10.2 Turbine Generator

The information in this section of the reference ABWR DCD, including all subsections, tables and figures, is incorporated by reference with the following departures and supplements.

Figure 10.2-1 Turbine Stop Valve Closure Characteristic

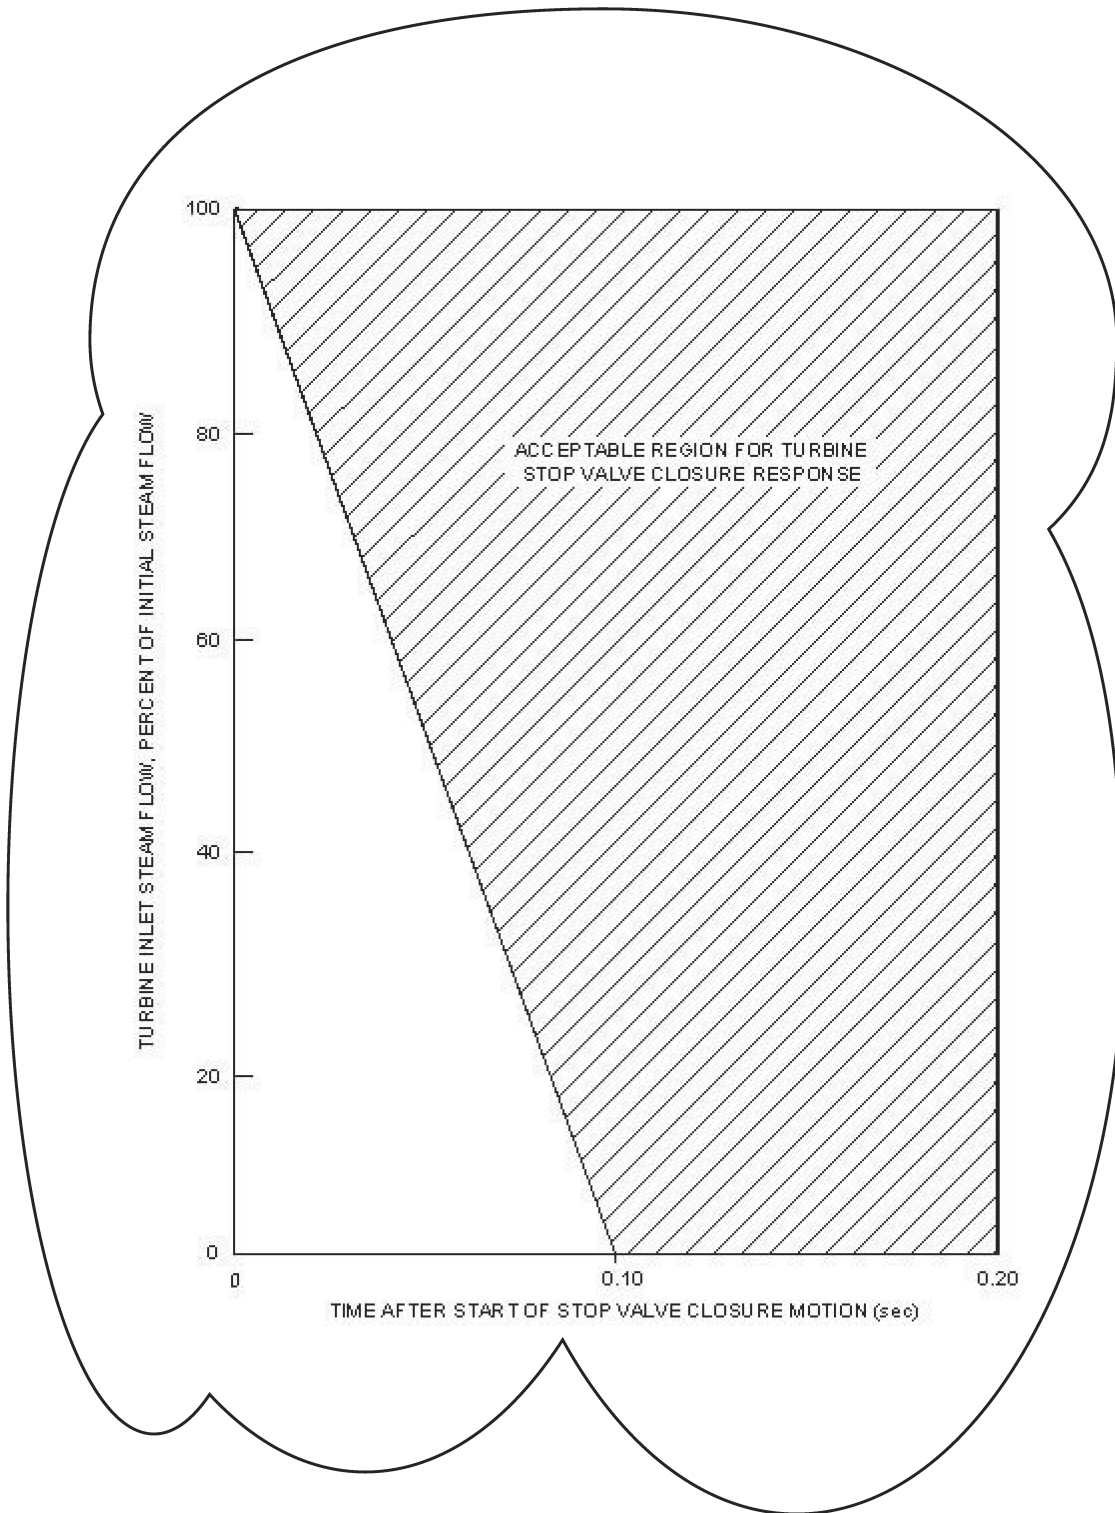
STD DEP Admin (Figure 10.2-1)

Figure 10.2-4 Generator Hydrogen and CO₂ System

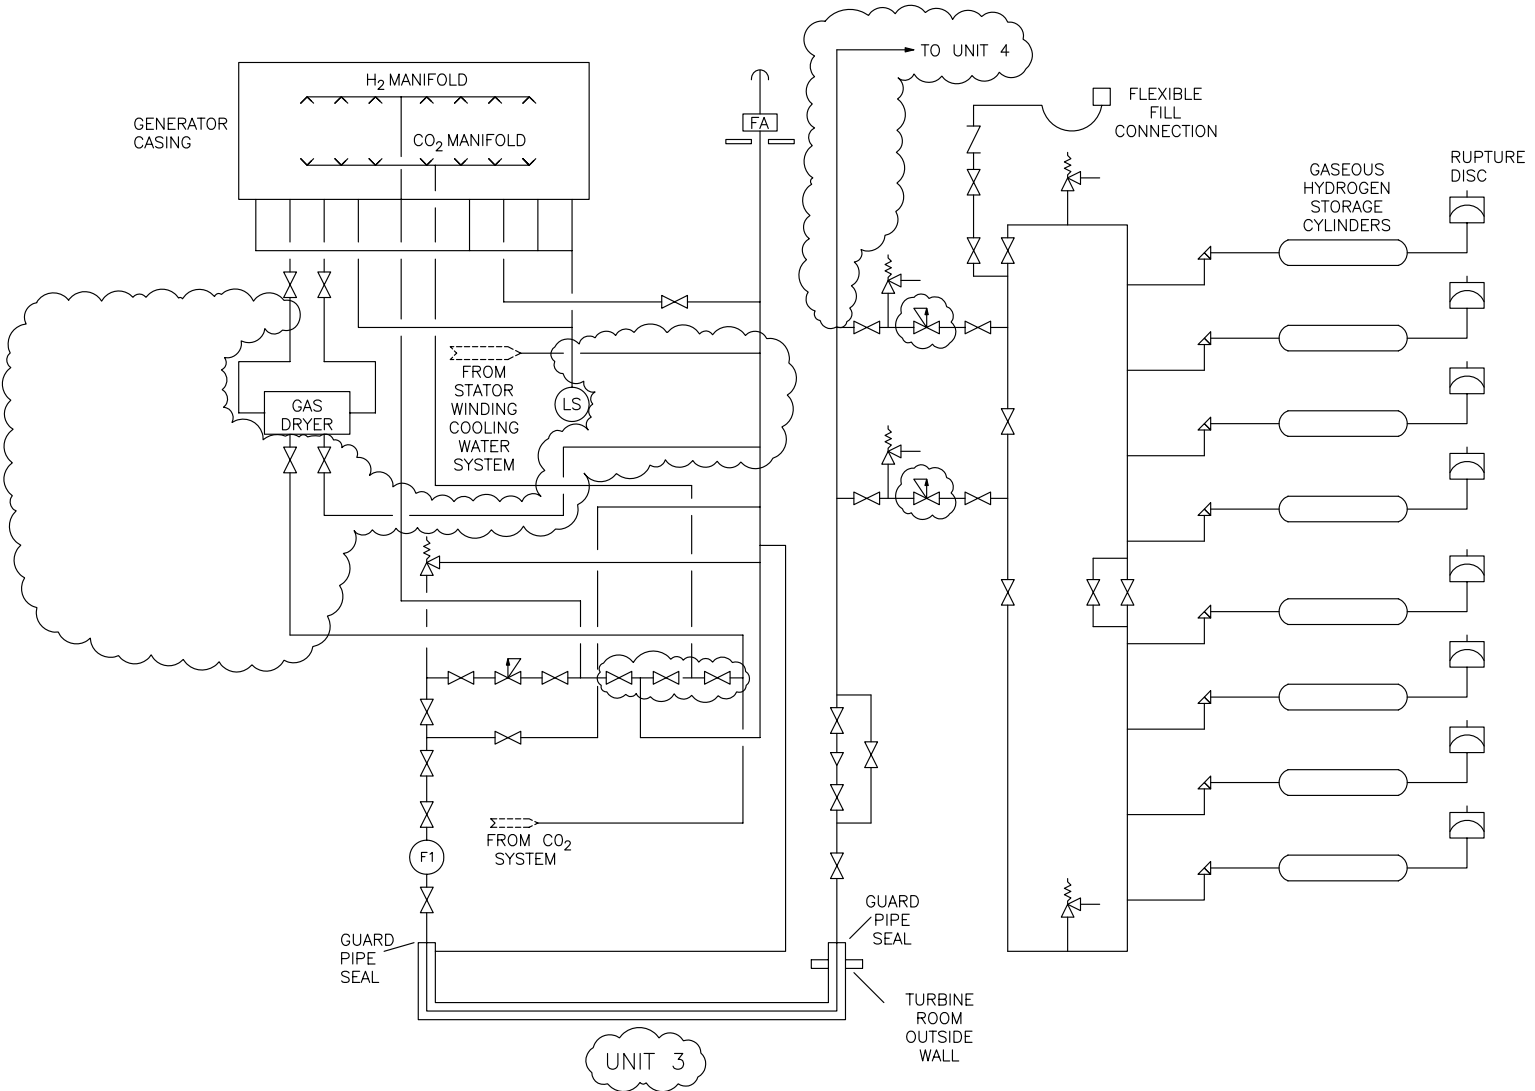
STP DEP 1.1-2 (Figure 10.2-4)

STP DEP 10.2-1 (Figure 10.2-4)

Bulk Hydrogen System—*The bulk hydrogen and CO₂ system is illustrated on Figure 10.2-4. The hydrogen system is designed to provide the necessary flow and pressure at the main generator for purging carbon dioxide during startup and supply makeup hydrogen for generator leakage during normal operation.*

Figure 10.2-5 Turbine Overspeed Trip System Functional Diagram

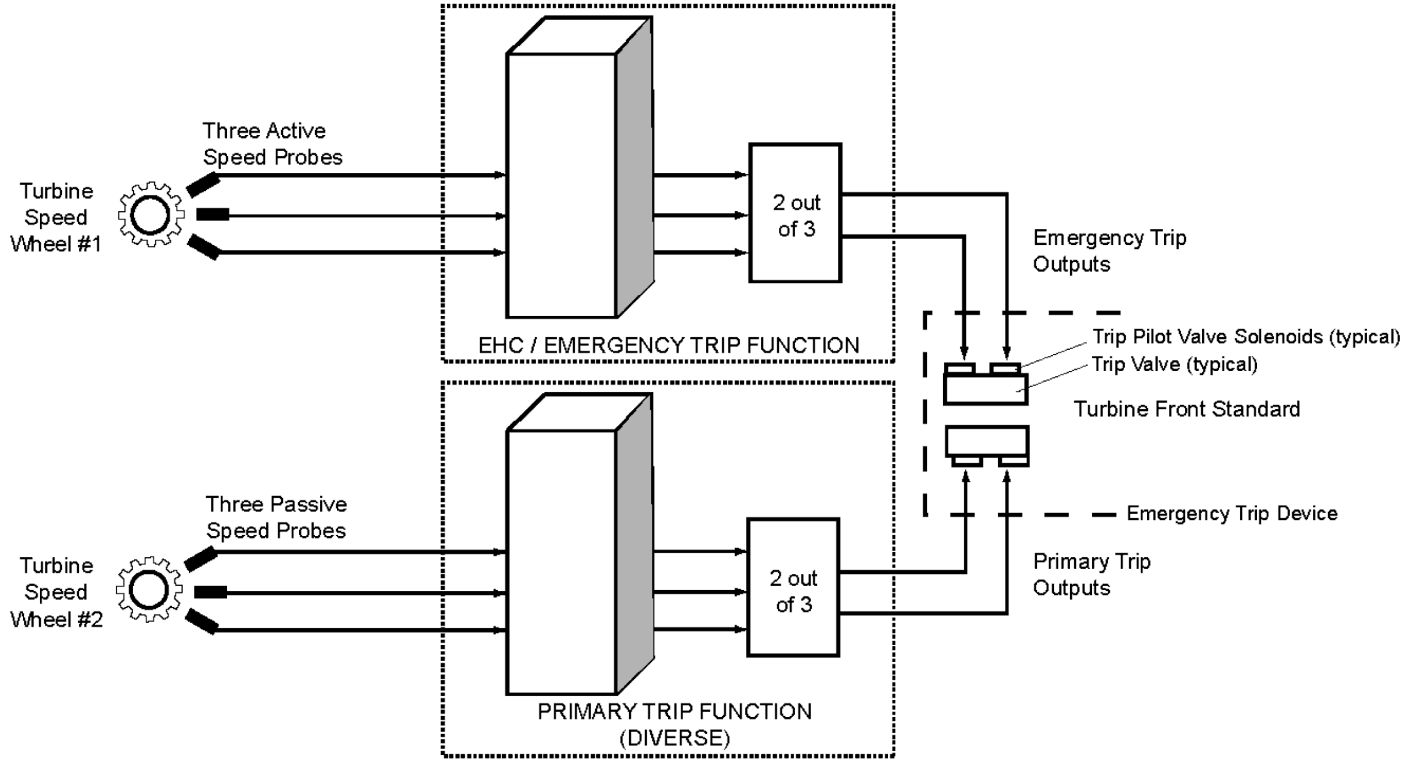
~~The overspeed trip system is electrical, redundant and consists of the Primary and Emergency overspeed trip functions. The primary trip function is independent and diverse from the emergency trip function as explained below (refer to Figure 10.2-5, Turbine Overspeed Trip System Functional Diagram). Reliability is achieved by using two sets of redundant speed sensing probes, which input to the independent Primary and Emergency Trip modules in the control system. For additional reliability, two-out-of-three logic is employed in both the Pprimary and Eemergency overspeed trip circuitry. EitherEach trip modulefunction can de-energize theits associated trip pilot valve solenoids of the electro-hydraulic Emergency Trip Device (ETD). The ETD is composed of two independent trip-solenoid valves, each with two normally energized fail-safe solenoids-operated pilot valves. For each trip valve, each trip pilot valve solenoid is powered from a separate power source. The solenoids-operated pilot valves de-energize in response to detection of an overspeed condition by the turbine speed control logic. De-energization of both solenoid-operated pilot valvestrip pilot valve solenoids is necessary to cause the spool in their respective trip-solenoid valve to reposition, which depressurizes the emergency trip fluid system, rapidly closing all steam inlet valves and indirectly closing the steam extraction nonreturn valves.~~ Accordingly, the repositioning of only one of the two trip-solenoid valves is necessary

The diverse primary overspeed trip function utilizes three passive speed sensors that are separate from the active speed sensors used for normal speed control and emergency trip function. Speed sensors are diverse (passive and active sensors) between primary overspeed and emergency overspeed trip. Speed sensing for primary and emergency overspeed trip functions also use separate speed wheels (refer to Figure 10.2-5). Each speed signal for the primary trip function is compared to a speed setpoint of approximately 110% of rated speed, and produces trip signals arranged in two-out-of-three logics, to de-energize both trip pilot valve solenoids of one of the two trip valves of the ETD. Both trip pilot valve solenoids must be de-energized to trip the associated trip valve. The ETD has two redundant trip valves. Tripping of either redundant trip valve will drain the emergency trip fluid, resulting in a turbine trip.

The emergency overspeed trip function is the redundant backup electrical overspeed trip and uses three active magnetic pickups to sense turbine speed that are separate from those used by the primary overspeed trip function. The speed setpoint for the emergency overspeed trip function is approximately 111% of rated speed.
